STAFF REVIEW AND RECOMMENDATIONS
PUBLIC HEARING
NOVEMBER 15, 2023

ABBREVIATED PLAT: SUNSET 2023

CASE #: 2023-123

REQUEST: The request is to create four lots from Lot 4, Sunset, Plat No. 71-5, to be known as **SUNSET 2023**, containing 9.27 acres +/- . Parcel is located west of N. Meadow Lakes Loop and east of Seymour Lake; lying within Section 32, Township 18 North, Range 02 West, Seward Meridian, Alaska.

TH #3

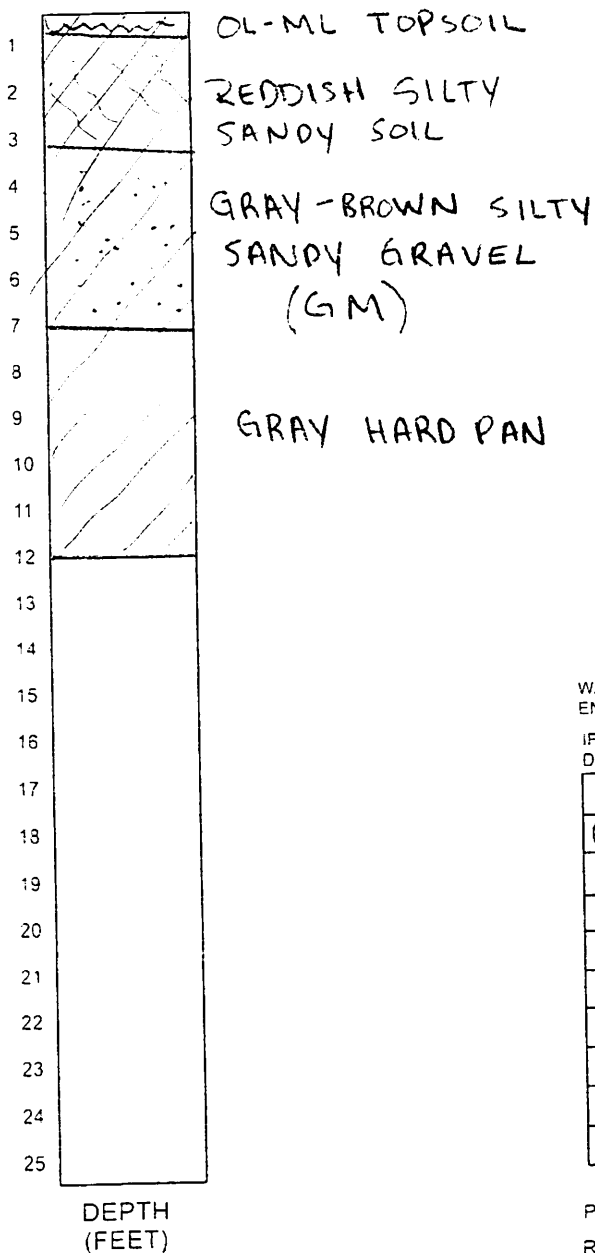
Provide additional information on "Gray Hard Pan" material on test hole 3. Is this a permeable or impermeable layer?

Regarding Mr. Daniel's question regarding the hard pan on test hole number 3.
Hard pan is typically impermeable subject to a perk test or sieve analysis it cannot be visually rated
however test hole number 3 is in an unusable area (P.U.E) therefore we dug test hole number 4 120 feet
away to verify better soils therefore test hole number 3 is unusable.

Map Title

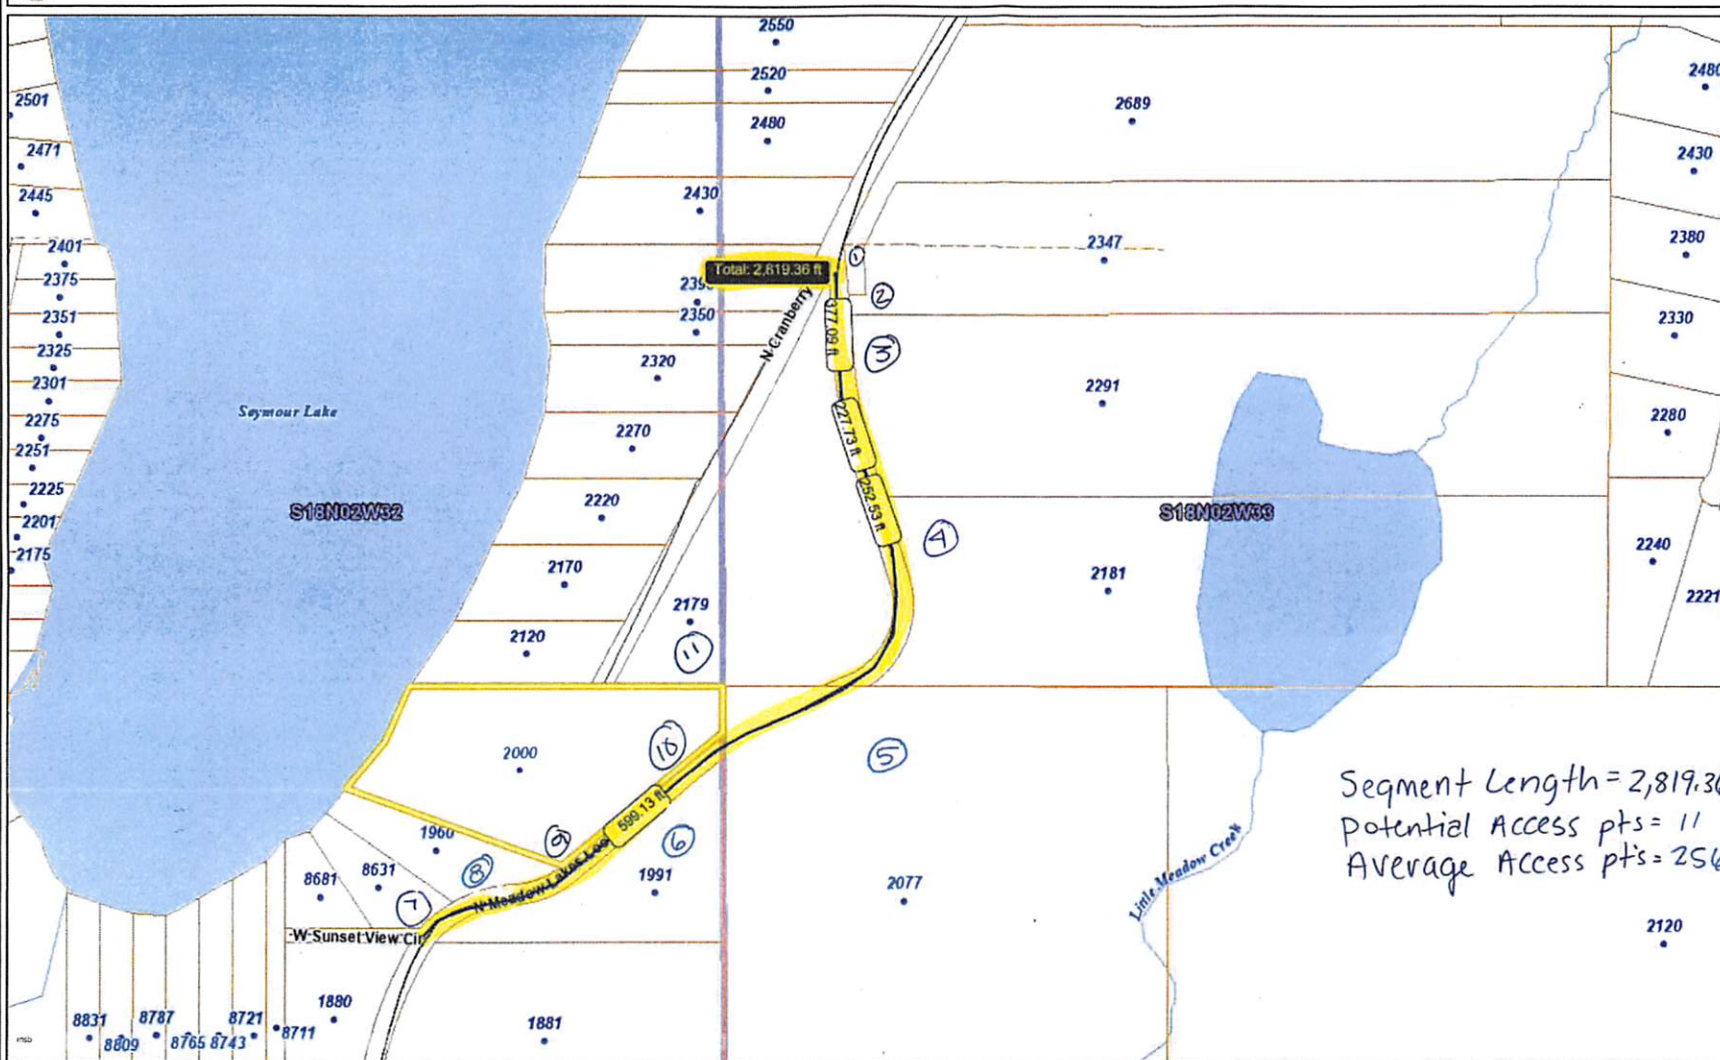
Hayli: See Jamie's comments below. Please have Wayne calculate average point spacing using SCM A04.3(b) using Cranberry Lane and Sunset View Circle. I have to have this staff report written up on Thursday, as Friday is a holiday. If I don't have the calculations by Thursday AM, I will need to continue this case. Thanks, A.

The petitioner still needs to provide the average access point spacing per SCM A04.3(b) to show that it is a minimum of 250 feet. Average access point spacing is to be calculated between two significant intersections, in this case between Cranberry Lane and Sunset View Circle.

Segment Length = 2,819.36' ±
Potential Access pts = 11
Average Access pts = 256.31' ±

$$2,819.36' \div 11 = 256.31'$$

PRELIMINARY PLAT

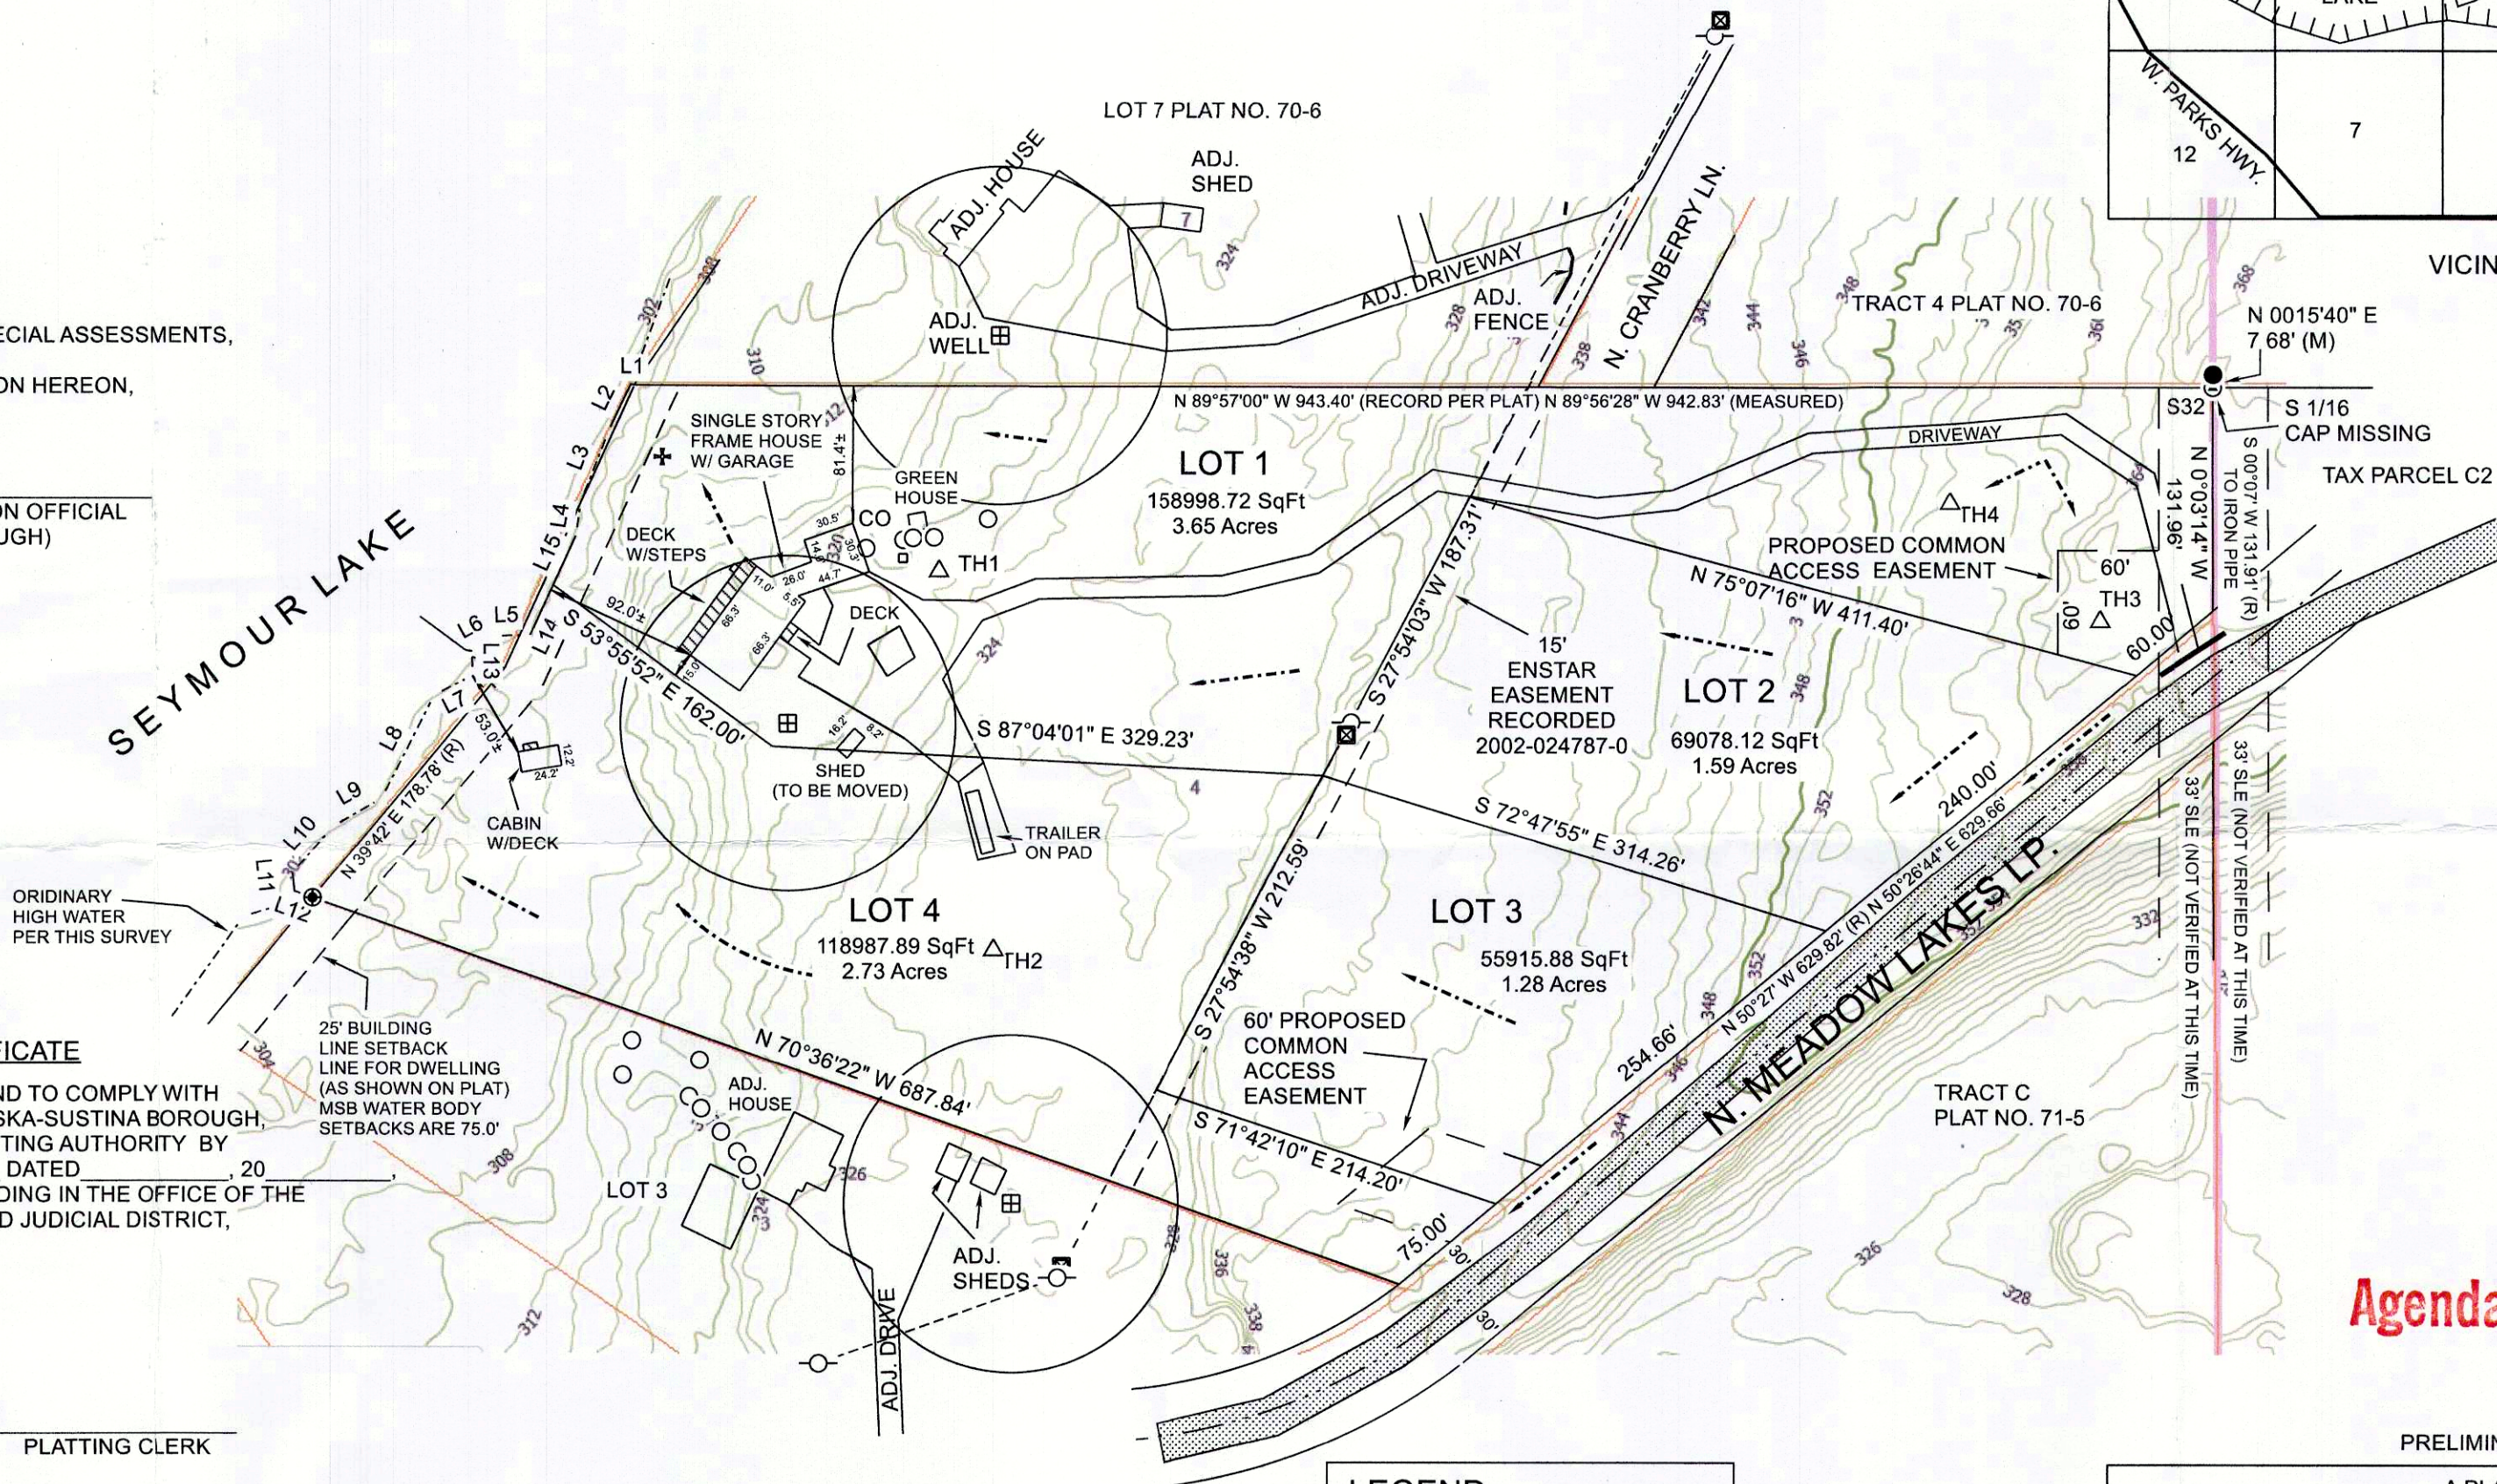
Since Meadow Lakes Loop is classified as a minor collector, per SCM A04.3 (b), applicant needs to calculate average access point spacing.

MTA would like the developer to recognize the existing MEA power line and MTA easement recorded in Bk 814/page 437 that is currently in place. Any improvements to existing driveways, or construction of new driveways must maintain 4' of fill over existing MTA buried cables, and assume any costs associated with lower or changing grade that would impact MTA buried cables. MTA would also request a 15' utility easement on lots 1,2,3 and within the common access easements adjacent to N Meadow Lakes Loop.

Regarding Mr. Daniel's question on how we calculated the average access point.
We took the distance of 629.66 ft. and divided it by the number of lots that could potentially access it
and came up with a distance of 125.93 ft. however the adjacent lot already has an existing access point,
and our new lots will have shared access to N. Meadow Lakes Lp with a separation distance of 550.00 ft.
